ENVIRONMENTAL VARIANCE REQUEST REVIEW SHEET

CASE: SP-2008-0235D(R1)

PROJECT NAME: Travis County Eastside Service Center

MEMORANDUM

-14- Exhibit 4- WQZ and Floodplain Exhibit

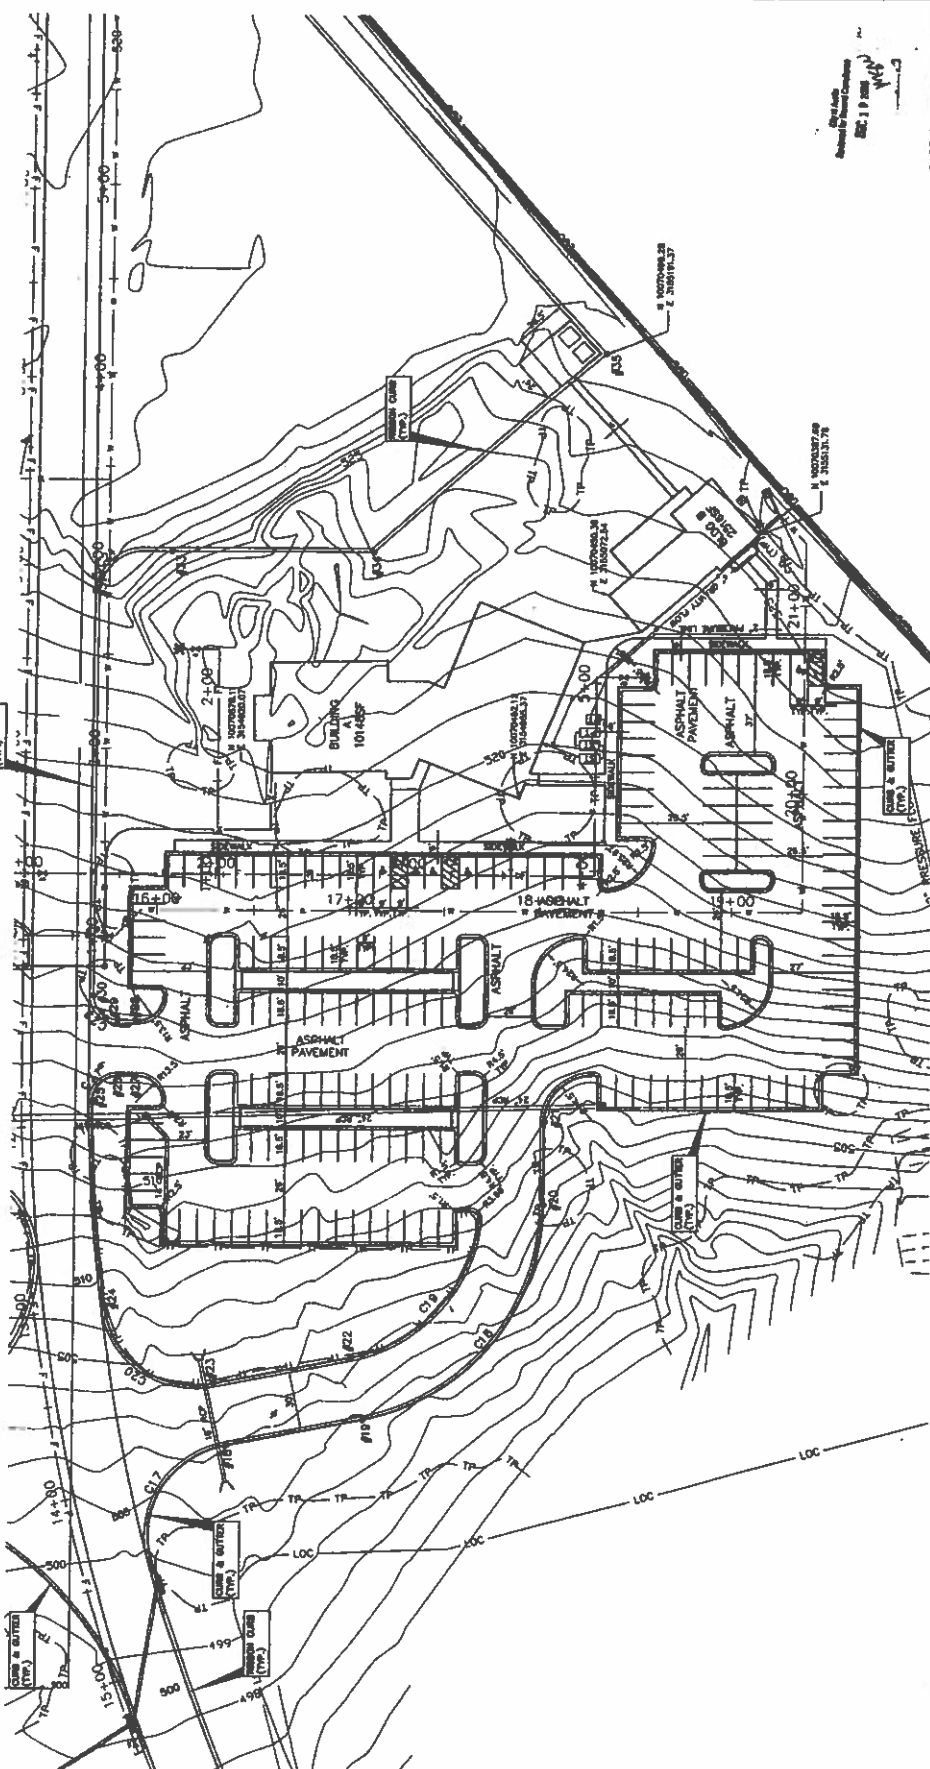
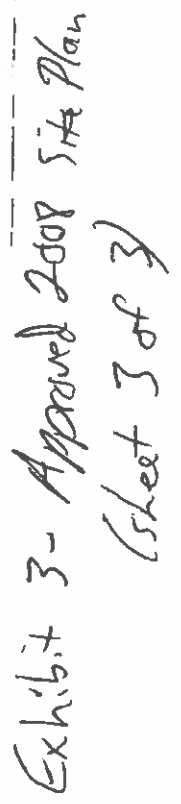
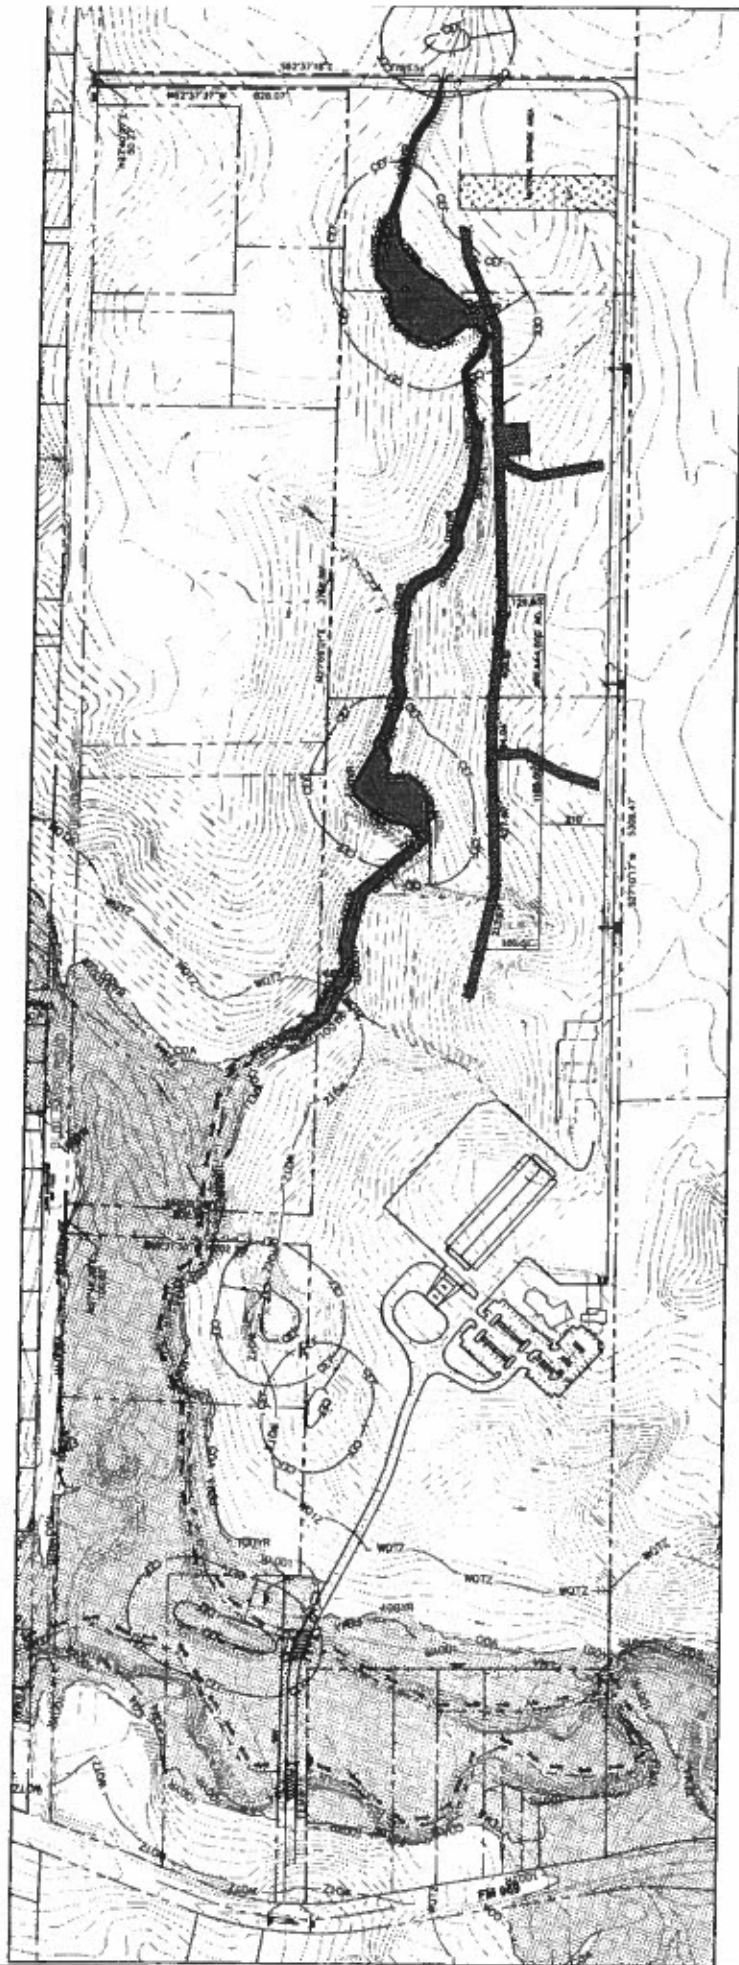
The driveway alignment crosses two approximately parallel, intermediate waterways (Exhibit 4 – Critical Water Quality Zone and Floodplain Exhibit). Within the property these waterways are adjacent to one another (approximately 450 feet apart) and converge approximately 1000 feet downstream of the property. The result of this waterway spacing within the property is that the critical water quality zones of each waterway overlap to create a single, widened critical water quality zone. The driveway alignment crosses approximately 620 feet of combined critical water quality zone. In accordance with LDC 25-8-392, a driveway may not be constructed in the critical water quality zone.

Land Development Code Section 25-8-392 states that Development is prohibited in a critical water quality zone, except as provided in Article 7, Division 1 (*Critical Water Quality Zone Restrictions*). Construction of a driveway is not one of the provisions of Article 7, Division 1. The driveway alignment crosses the critical water quality zone of two intermediate waterways.

The findings of fact for both variances have been met (Exhibit 9 – Applicant and Staff Findings of Fact). Staff recommends approval of Variance One and Variance Two with the following conditions:

1. The applicant will expand the conservation easement area from 4 contiguous acres to 5 contiguous acres; and
2. The applicant will plant at least 15 ECM Appendix F trees to be generally evenly distributed throughout existing parking lot islands and medians to help reduce the heat island effect.

Exhibit 6 - Site Photographs

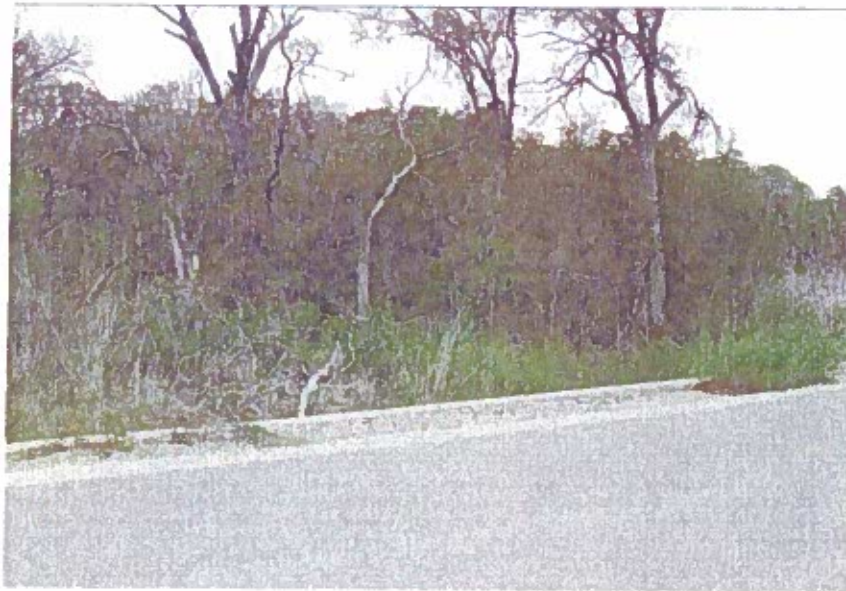
The project area is primarily wooded and canopy coverage is dominated by ashe-juniper, live oak, post oak, hackberry, and cedar elm. Various understory species include mesquite, yaupon, poison ivy, common greenbriar, agarita, tasajillo, and prickly pear. Common herbaceous species within the project area include bermuda grass, silver leaf nightshade, velvet leaf mallow, frostweed, bluebonnets, and other wildflowers (Exhibit 6 – Site Photographs).
